DONCASTER BEVERLY DANBURY RECONSTRUCTION

ASSESSMENT DISTRICT - 2024

CITY PROJECT NO. 14079
CONTRACT NO. 8709

REVISION #1- 8/15/2024
REVISED THE FOLLOWING:
EC4, EC6, G11, G13-G15, PD2-PD6, P2-P6, U4-U5, W1, X4-X5, X7, X9, X12

14079
 MADISON, WI
 8709
 CONTRACT NO.: 8709
 GREEN INFRASTRUCTURE 4256 BEVERLY
 DONCASTER DR, BEVERLY, DANBURY ST RECONSTRUCTION
 M:\DESIGN\Projects\14079\CAD\TerraceRG\14079EN-TerraceRaingardens_recover.dwg
 Scale: #####
 Date: 5/7/2024 8:58 AM
 REVISION
 MARK
 DATE
 BY
 GI 3

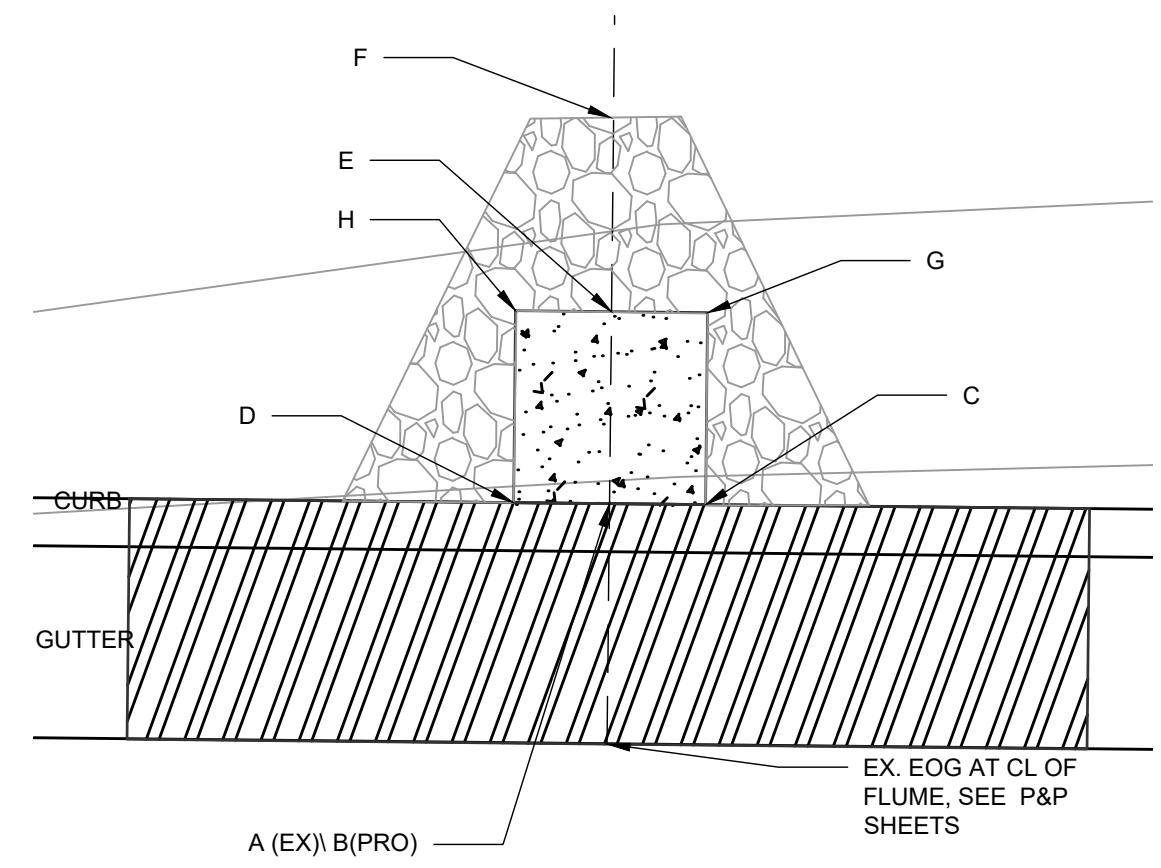
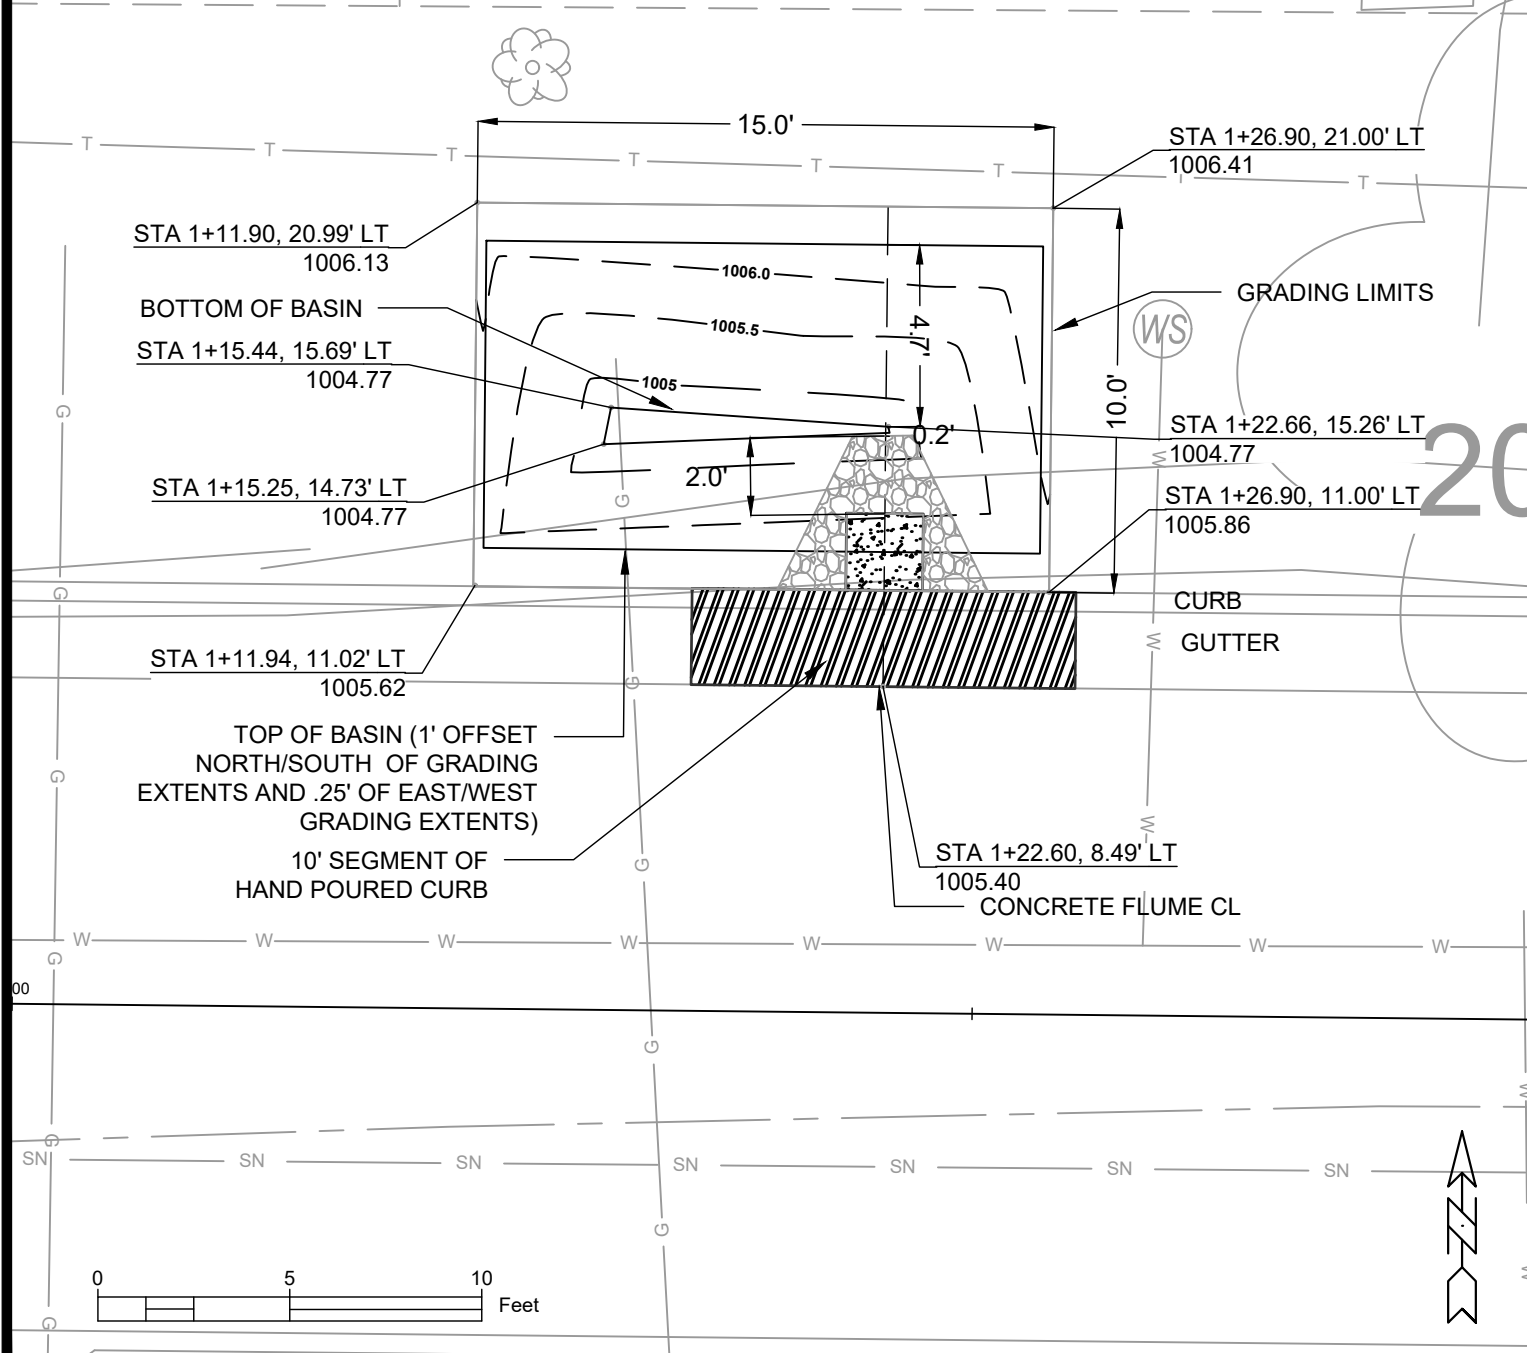
ADDENDUM NOTE:
 RENUMBERED SHEET
 FROM GI-3 TO GI-2

REVISION 1:
UPDATED TO
NEAREST ALIGNMENT

8709
GI-3

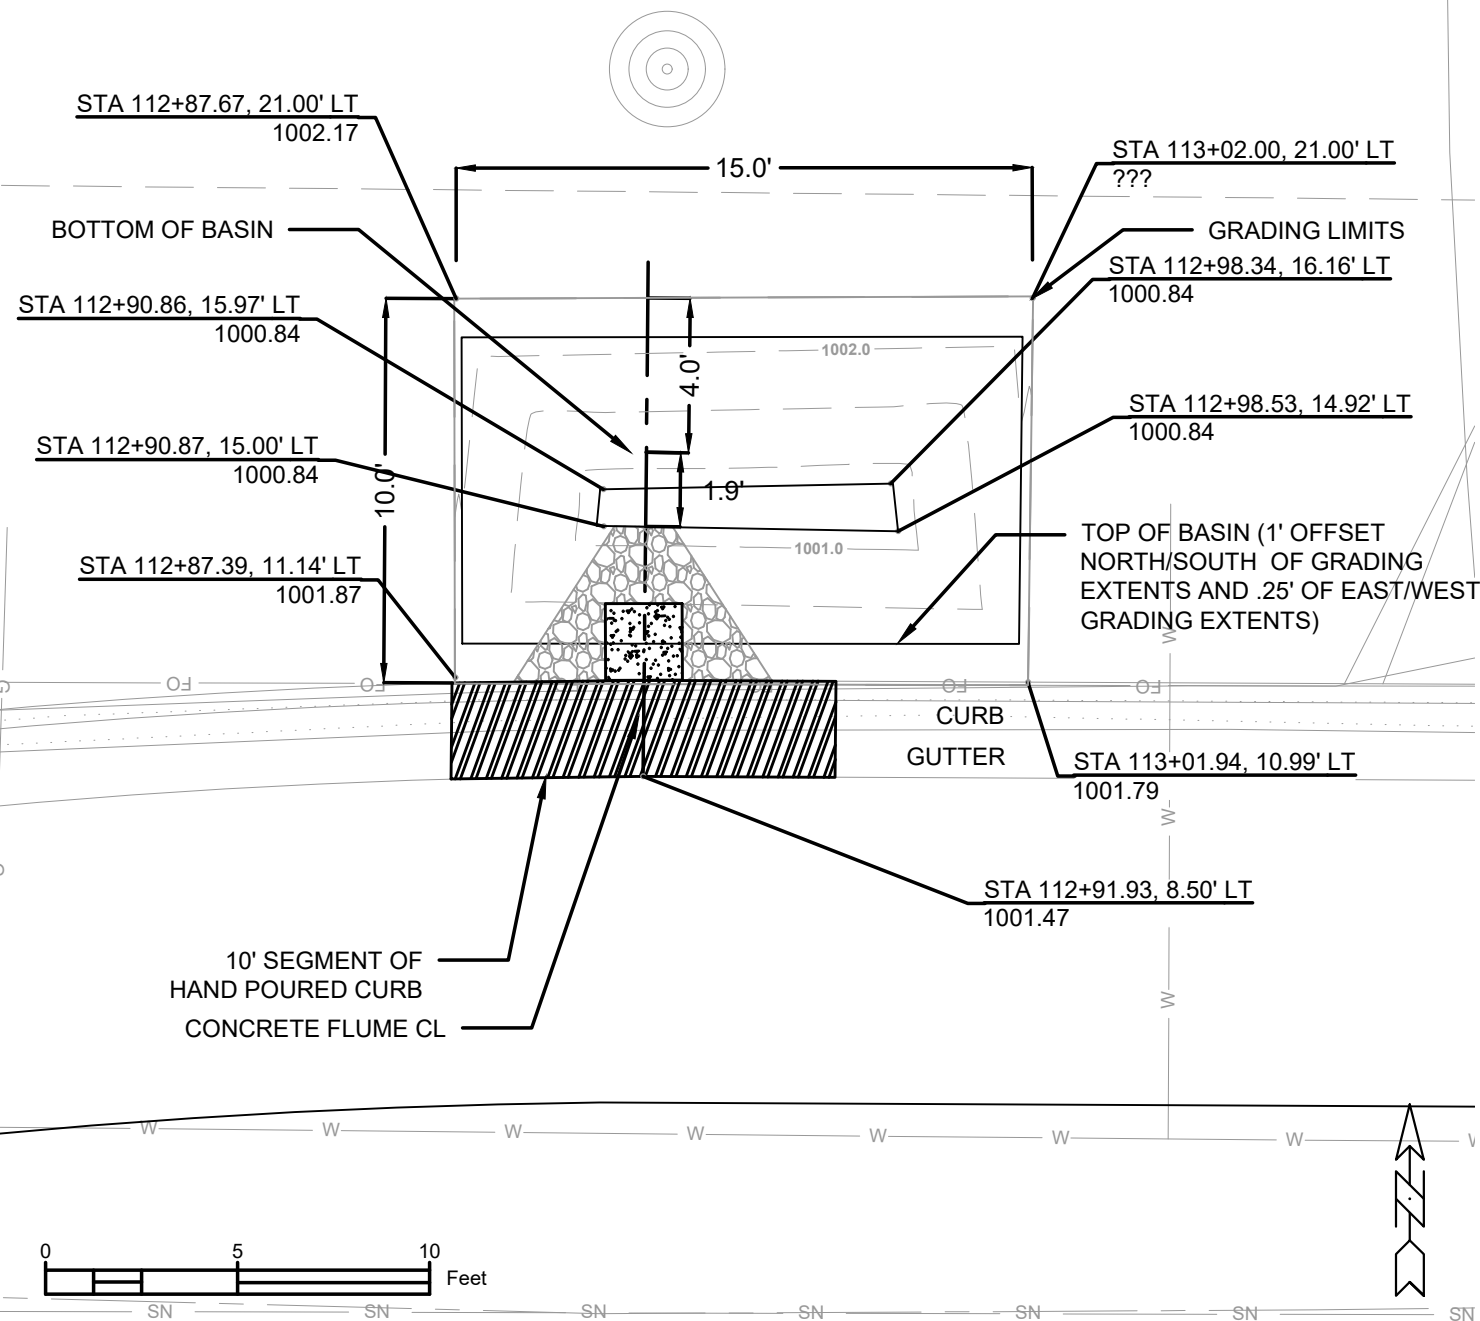
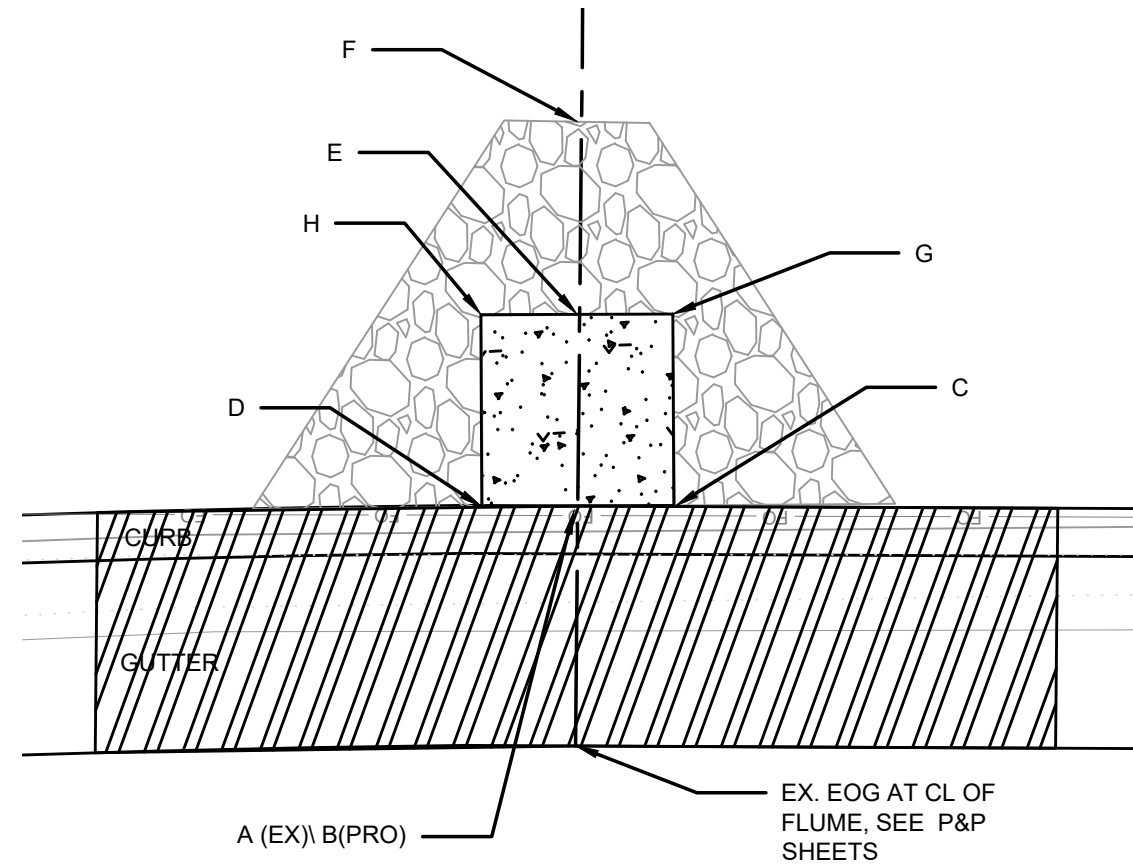
REVISION 1:
UPDATED TO
NEAREST ALIGNMENT

DATE	BY	REVISION	SCALE	GI 5 14079 8709 14079
GREEN INFRASTRUCTURE 4206 DONCASTER DONCASTER DR, BEVERLY, DANBURY ST RECONSTRUCTION M:\DESIGN\Projects\14079\CAD\TerraRGI\14079EN-TerraRgarden.dwg				8709 GI-4
CITY OF MADISON WISCONSIN				
CONTRACT NO.: 8709

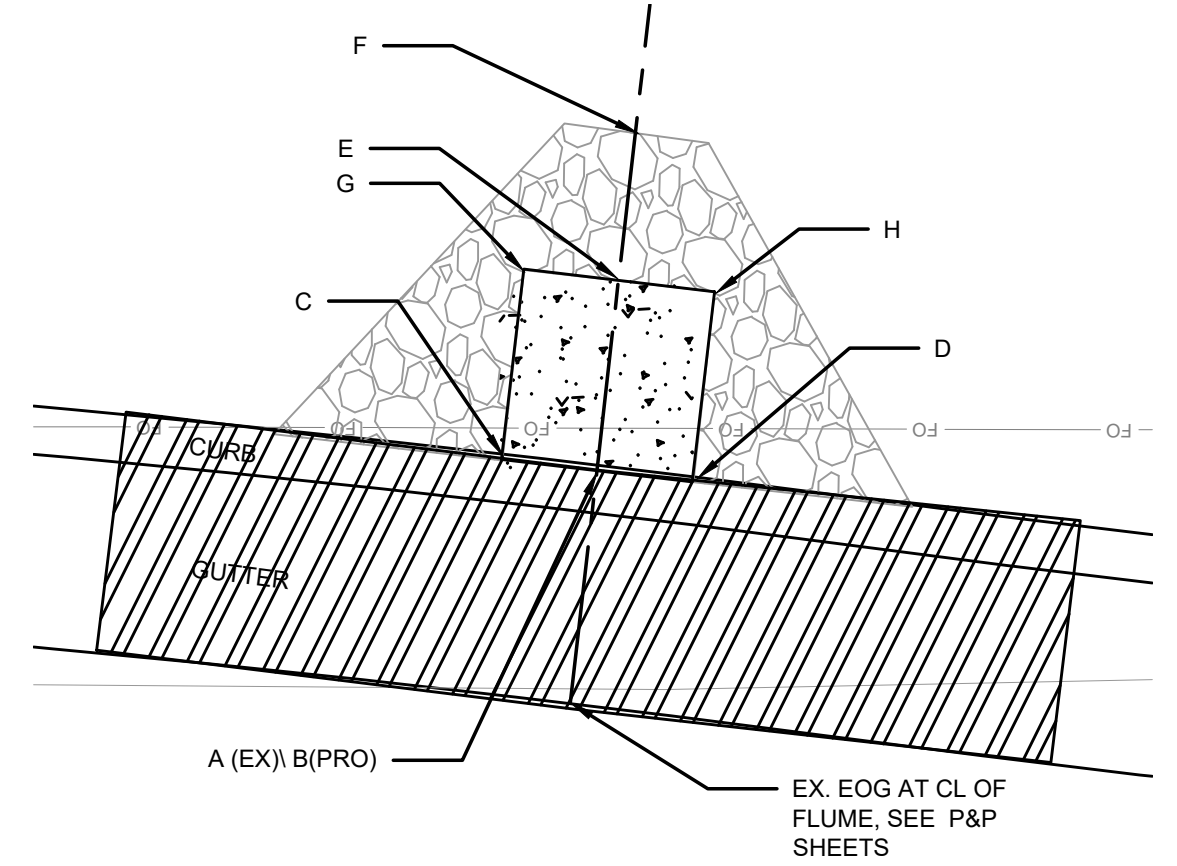
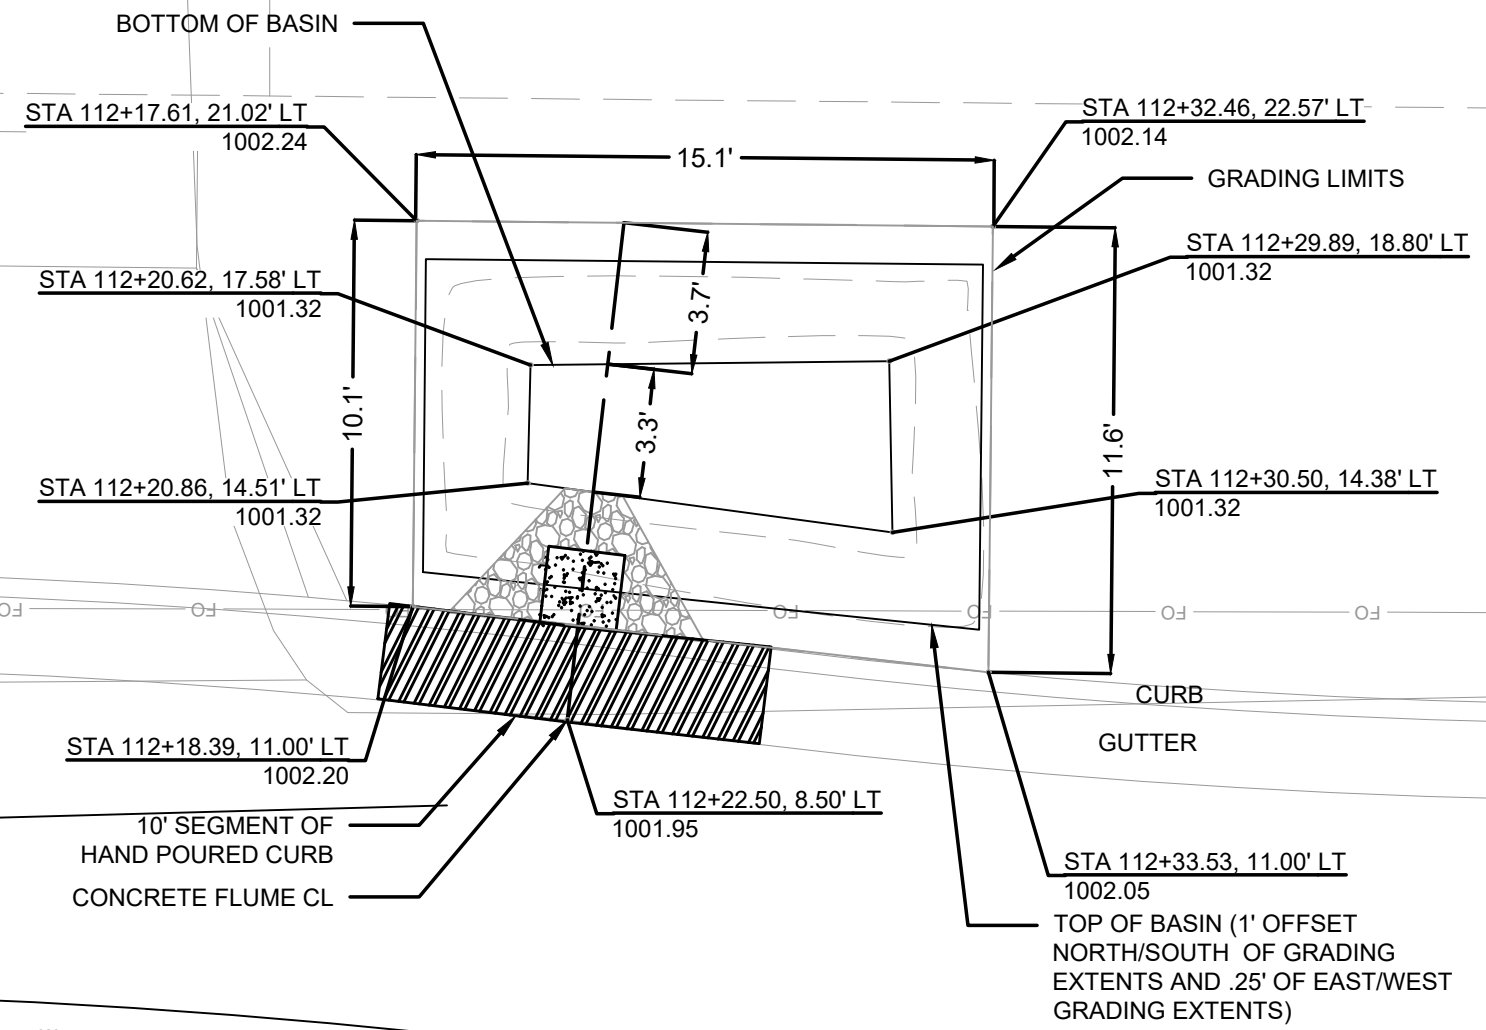
REVISION 1:
UPDATED TO
NEAREST ALIGNMENT
